SUBJECT: Department of Defense Explosives Safety Board (DDESB) Approval of Amendment 8, Approved Conventional Explosives Safety Submission (ESS) Munitions Response (Removal) Eastern Bypass, Fort McClellan, Alabama with Amendments 1 through 7

Withdrawal of Requirement to Post Warning Signs along the
Eastern Bypass Ordnance and Explosives Site – 2

Amendment 8
To the Approved Conventional Explosive Safety Submission, Munitions Response
(Removal), Eastern Bypass, Fort McClellan, Alabama

Figure 2

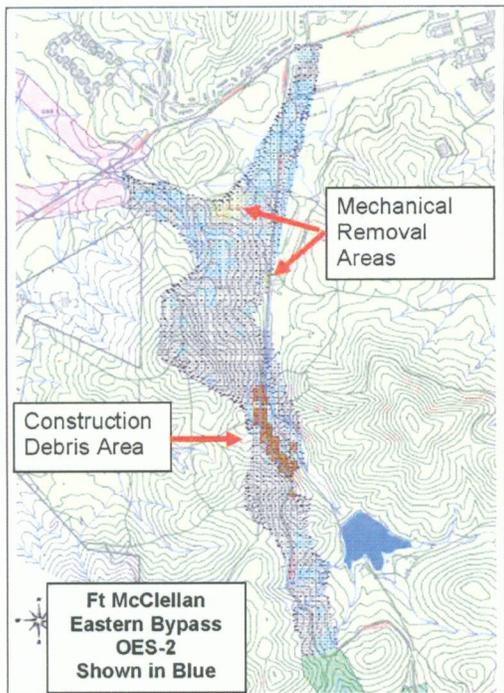
From April 2001 to April 2003, under contract with USAESCH, Tetra Tech Foster Wheeler performed a clearance to depth on 255 acres in OES-2. This munitions response as shown on Figure 2, included a mechanical removal to depth in areas that were heavily contaminated with MEC and metallic debris.

Because all of the Eastern Bypass OES-2 has been cleared to depth with the exception of the 30 grids that will be covered with a minimum of 4 feet of fill during Bypass construction, the requirement to post signs prohibiting excavation activities in OES-2 is removed from the selected remedy documented in the Action Memorandum. There is no cost to implement this action.
